RE: Remarkables Ski Area Upgrades and Doolans Expansion – Response to Landscape Feedback

PEER REVIEW MEMORANDUM REGARDING LANDSCAPE AND VISUAL EFFECTS ASSESSMENT

DOC Memorandum on NZSki Landscape Effects Assessment

Return Trail to Sugar Basin

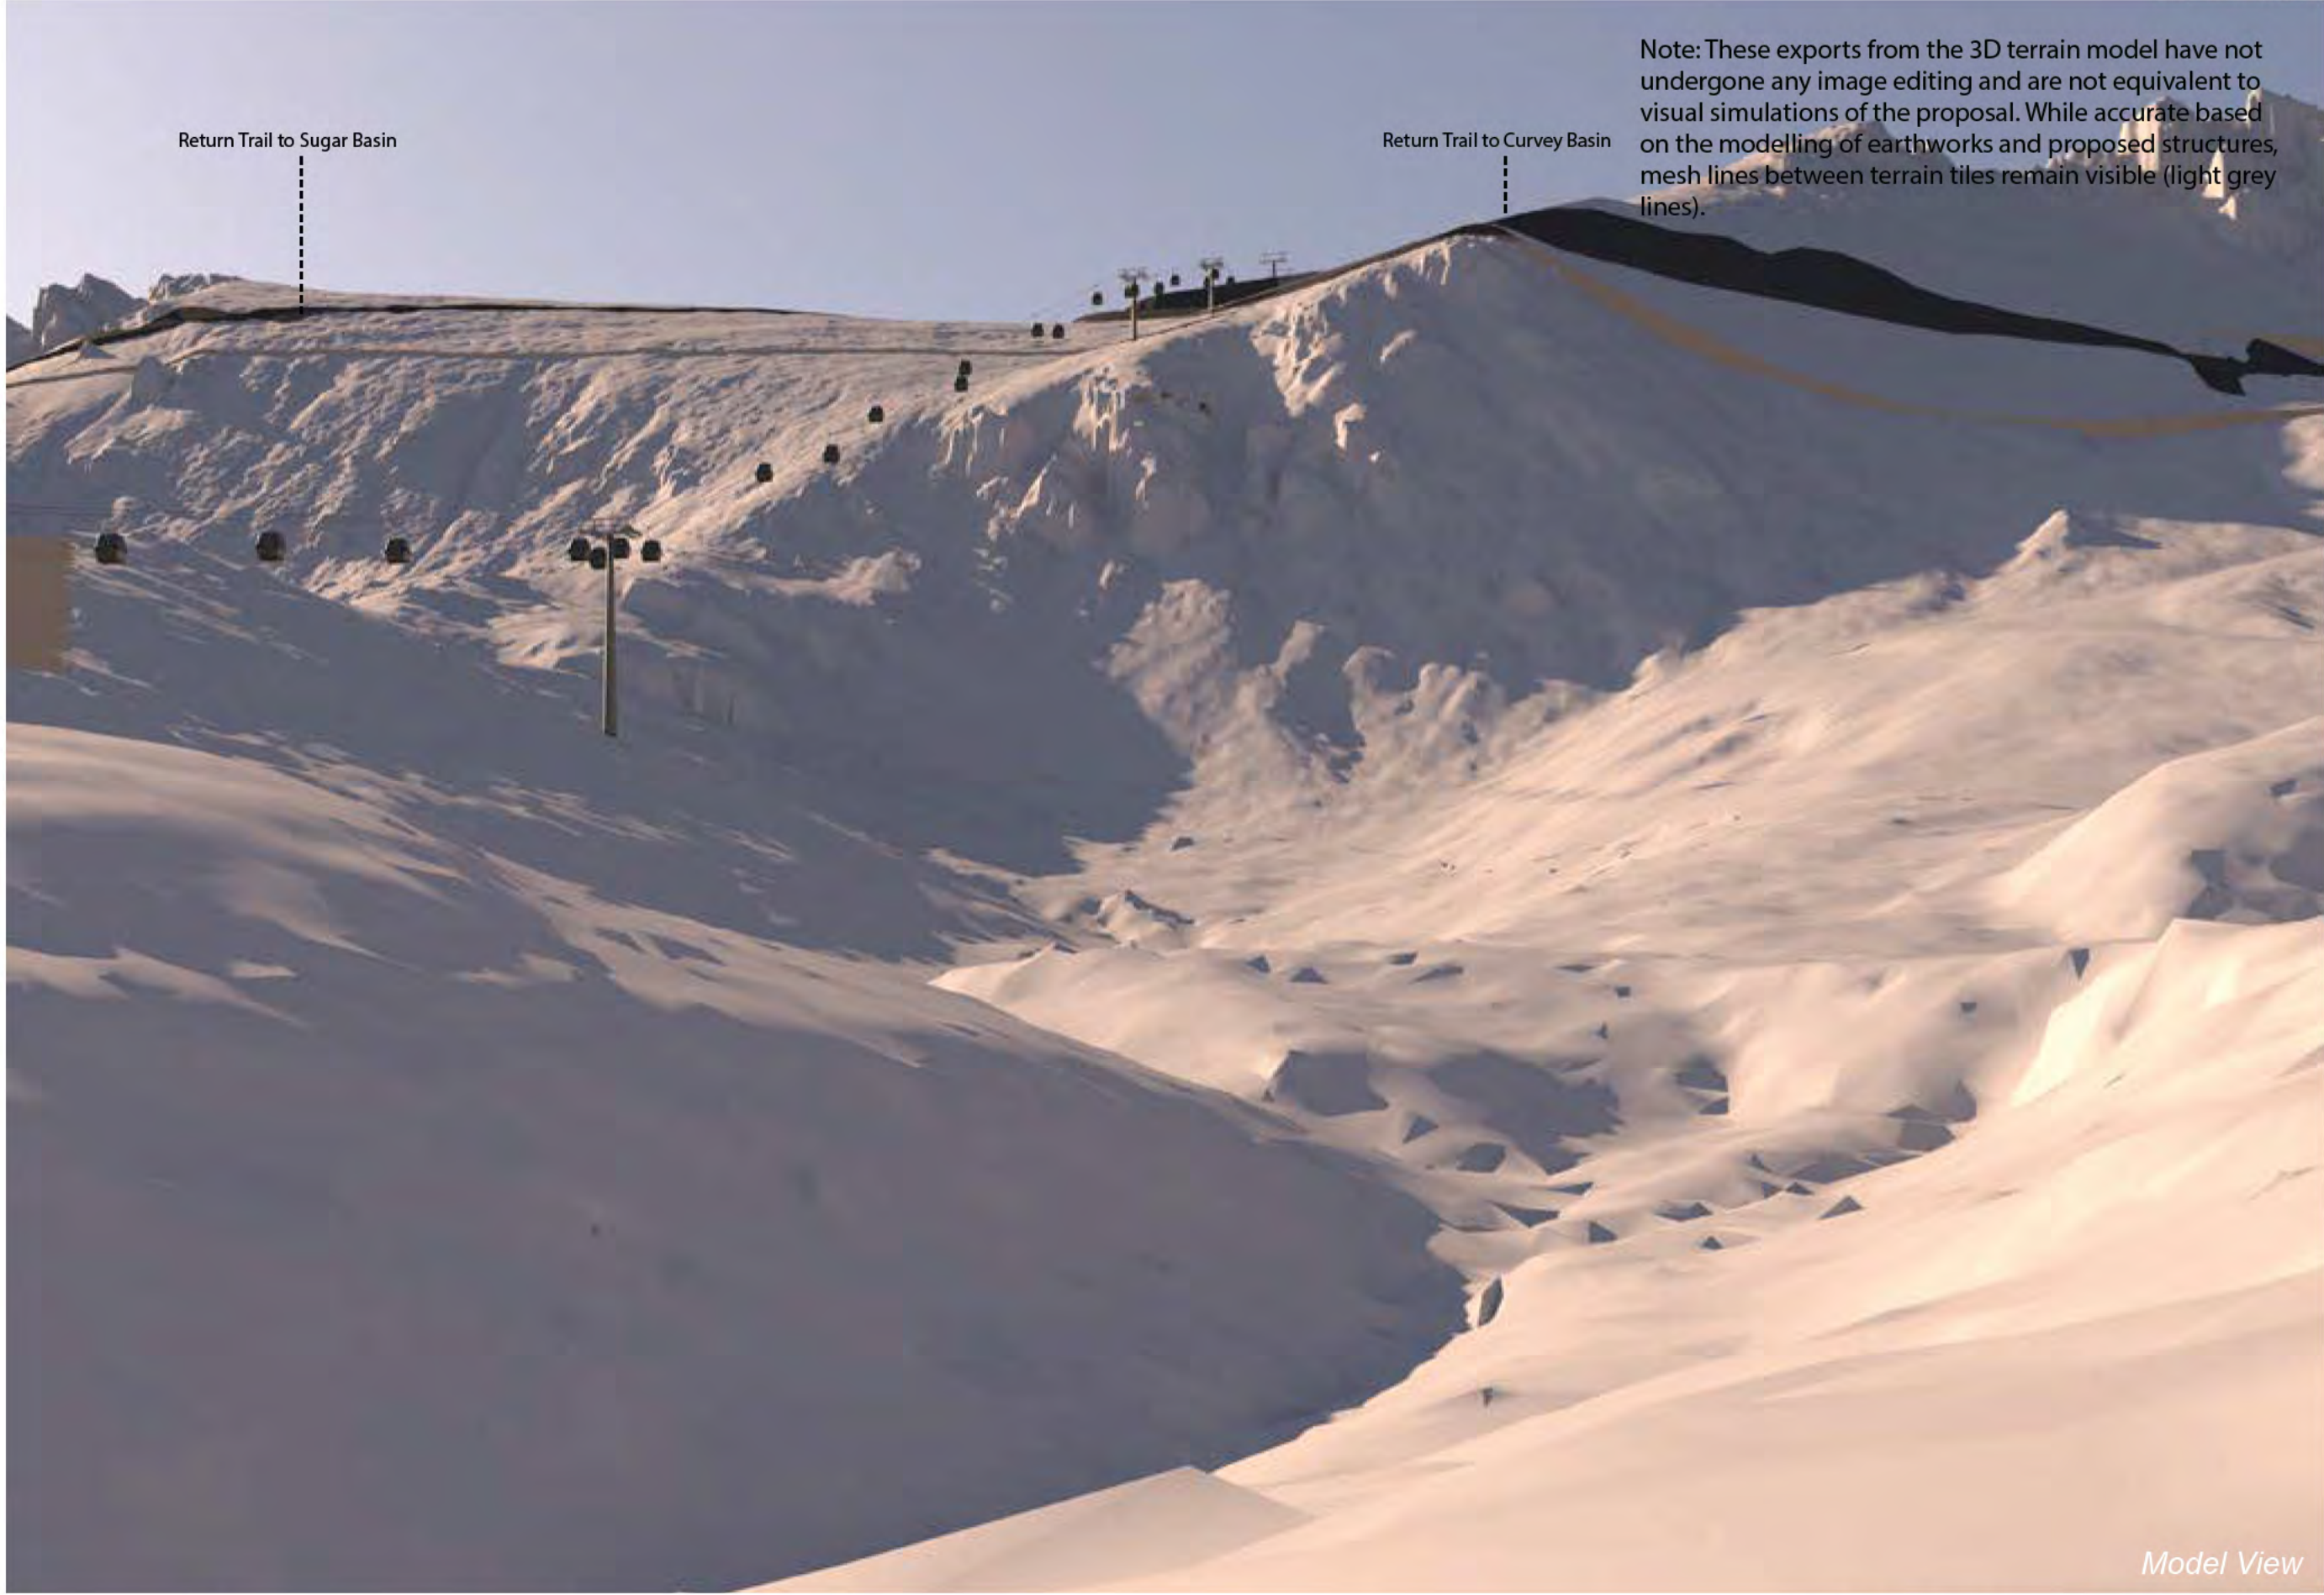
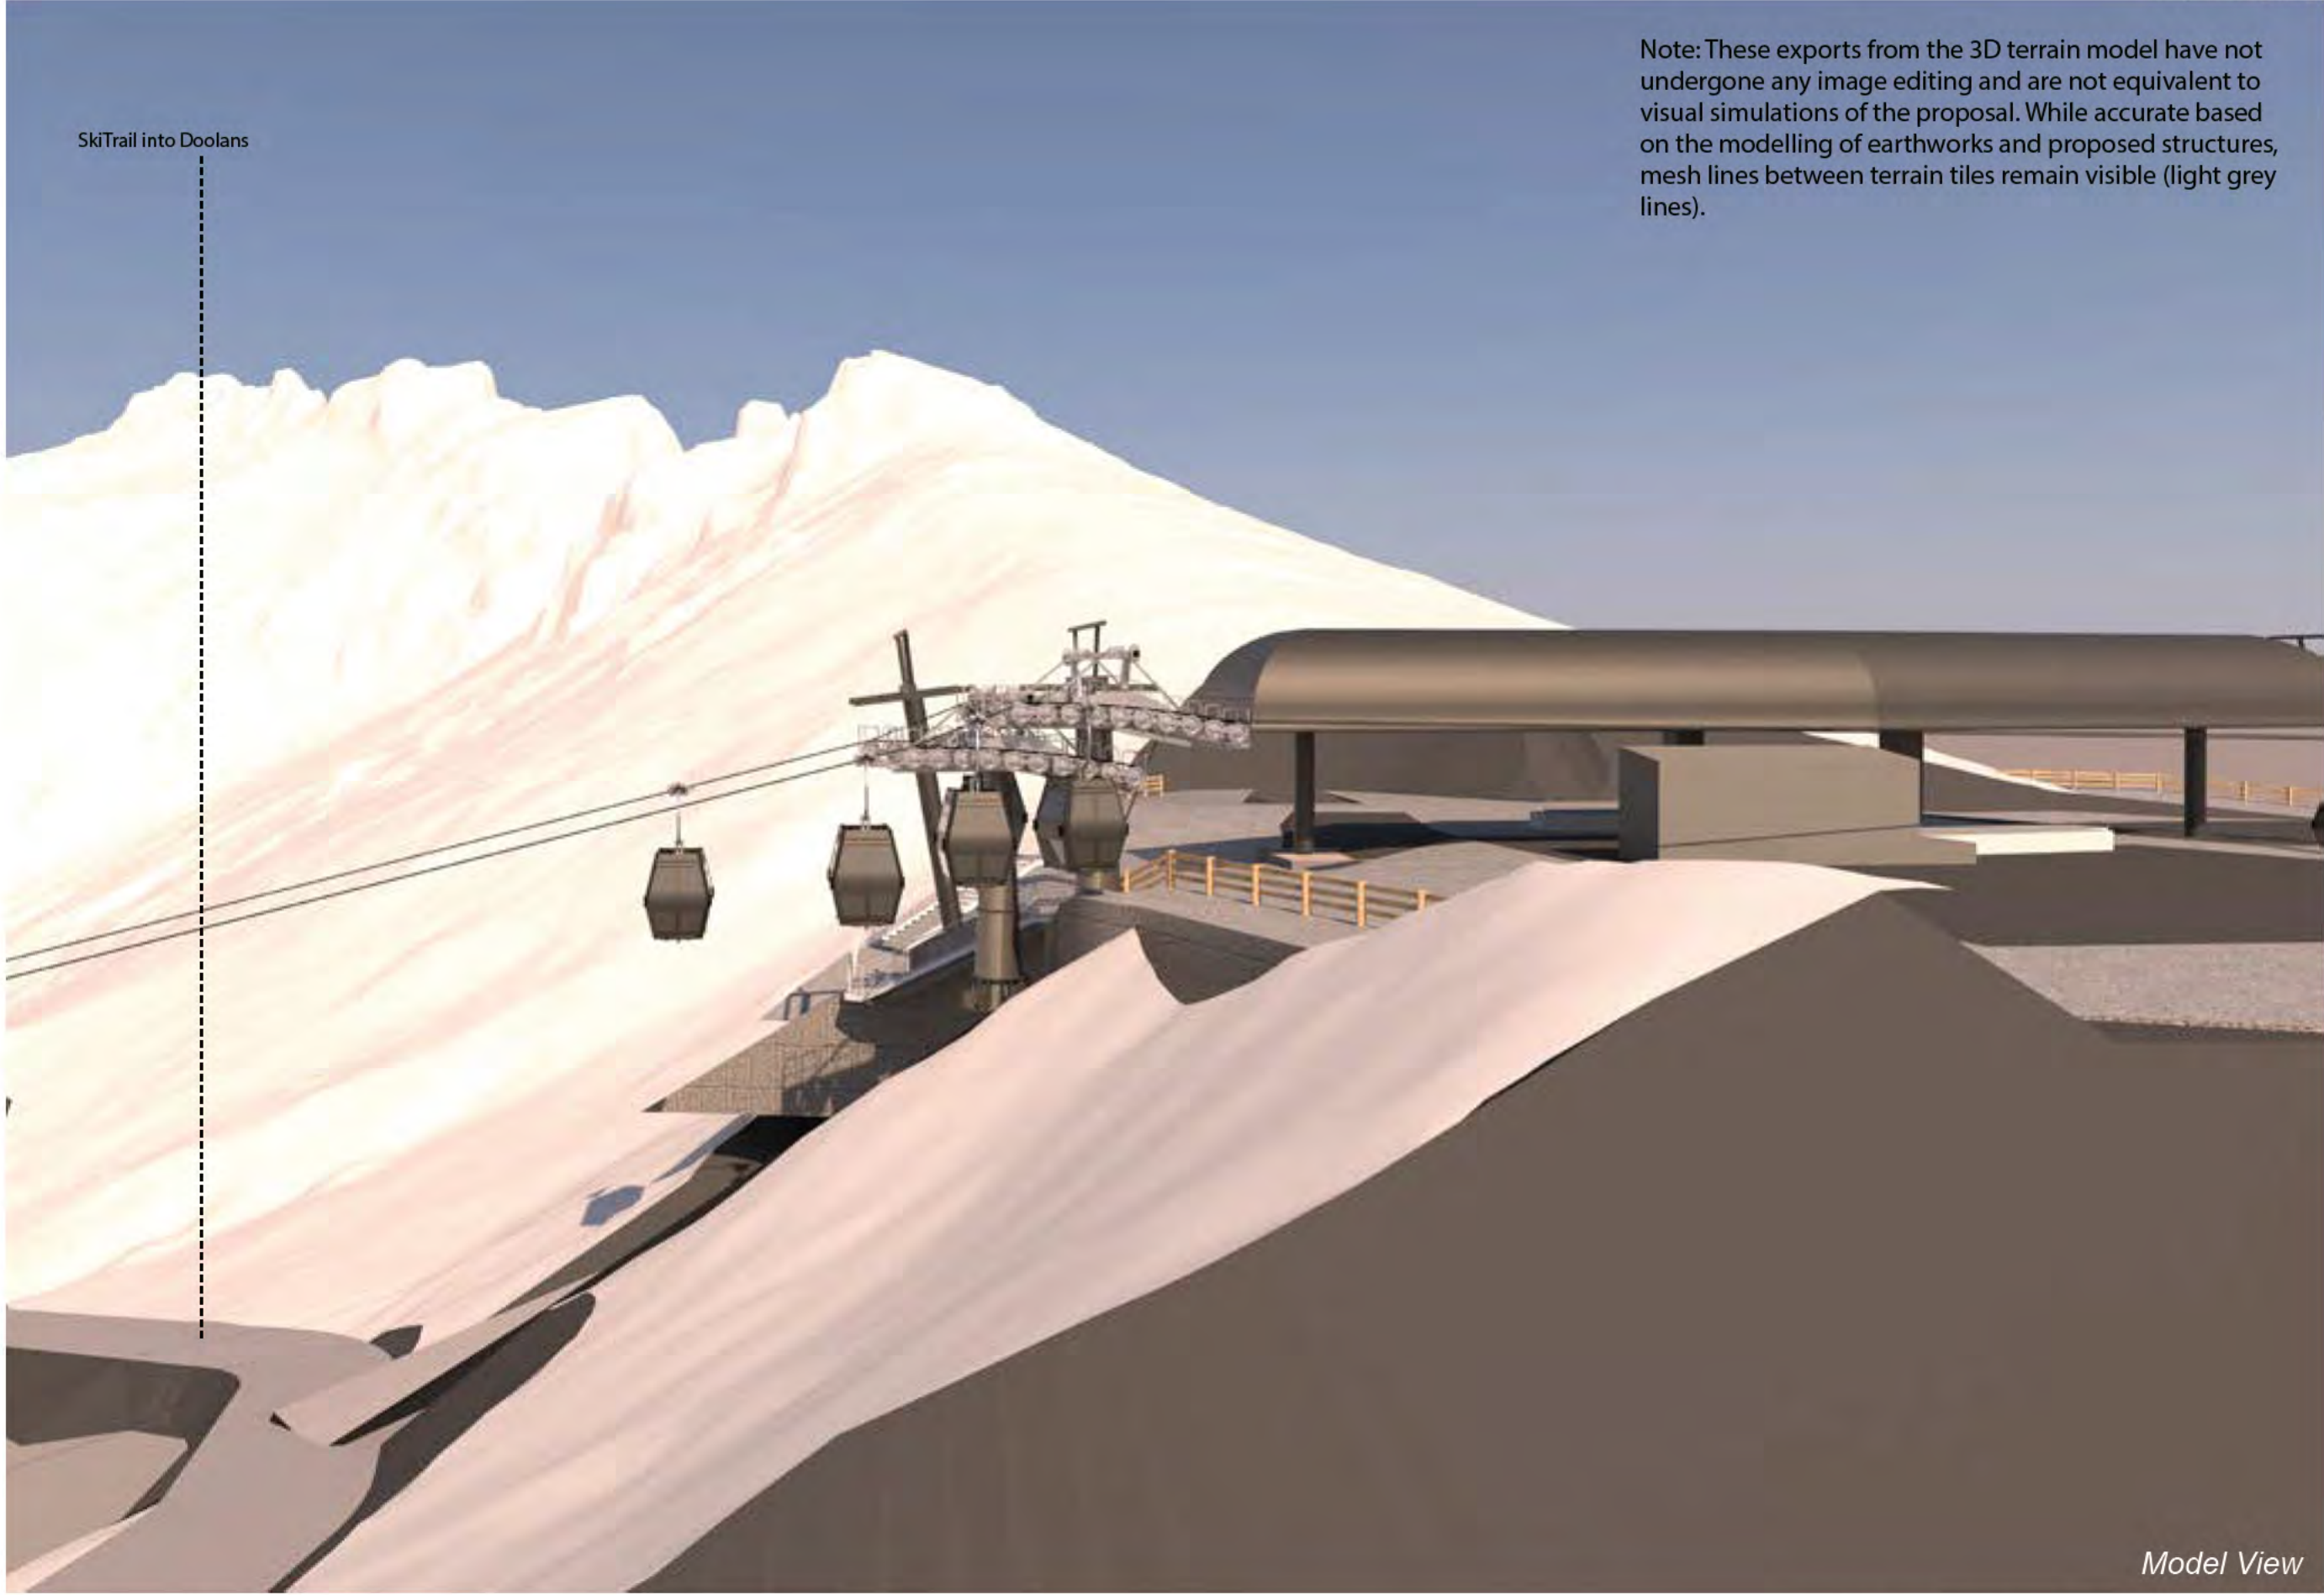
2. NZSki to provide views of the proposed mid-station in relation to the surrounding landform and landscape context.

19. The mapping in the 6 May 2026 B-031.1 Remarkables Ski Area Upgrade and Doolans Expansion Landscape Graphics (Figures 1, 2 and 4) is at a scale / level of detail where it is difficult to see where the proposed gondola mid-station is located. It is important that the various areas (QLD area and its mapped SASZ, the COD area, Rastus Burn Recreation Reserve and ridgeline) are accurately mapped along with the location of the mid-station building.

- > See attached Boffa Miskell memo and graphic supplement (**Attachment 3**)

The additional exports show both the mid station building and the earthworks required to establish the structure, including the proposed retaining walls and lift towers. In views within the ski field (see pages 1-10) the platform/retaining wall and lift tower will partially appear on the skyline, with the midstation structure itself largely out of view. For more distant views, the midstation will partially appear on the skyline (see visual simulation 3). However, in these views the structure is a comparatively small element.

On the Doolans side of the ridge the midstation is within a up to 10m high cut, but in nearby views from immediately below the structure (see Model view p.18) the mid station would protrude on the skyline. However, as shown in the ZTV, the mid station is obscured from substantial parts of the Doolans basin by intervening ridgelines. Pages 13-16 illustrate views of the mid station in views along the ridgeline to show the cut (Doolans side) and fill (Rastus Burn side) required to construct the platform. It is acknowledged that the visual effects of the mid station will be high when viewed within its immediate context along the ridge or from immediately below on the Doolans side. However, I maintain the view that visual effects of the mid station from the Rastus Burn side are mostly moderate, as the retaining wall partially obscures the structure in short-distance views and in long-distance views the structure is a relatively small element on a rocky ridgeline.
